Site Plan Review

Site: 27700 Southfield Road
Applicant: Akiva Investments, LLC
Plan Date: October 21, 2024
Zoning: VC Village Center District
Parcel ID: 24-13-303-021
Proposal: Mixed Use: Residential & Commercial

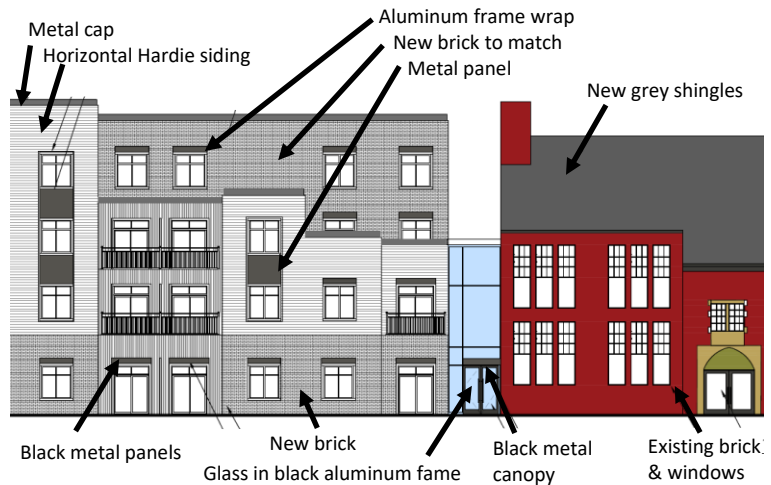
6. **Base Level (ground floor) frontage base types are required to consist of either an arcade or storefront, as shown in the image at right, or residential, which is subject to consideration and approval by the Planning Commission.** The proposed buildings consist of multi-family dwelling units with windows and private patio doors that reflect much of the intent of the standards of this section of the ordinance. Base level material consists of brick.

Per Section 3.1.8.E.1.A.iii., when ground floor residential use is permitted by the Planning Commission, there is no prescribed building frontage, except that **building fronts should generally run parallel to**

the street. Facades facing public rights-of-way, parks, and plazas should contain windows proportionate to the building façade.

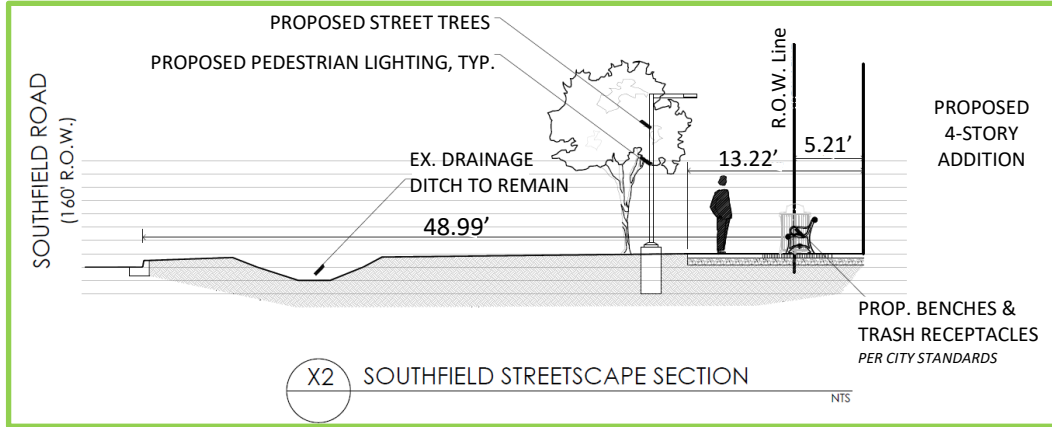
16. **The applicant shall coordinate with the City regarding the standard, vehicular streetlights required along each right-of-way.** See proposed cross section below.
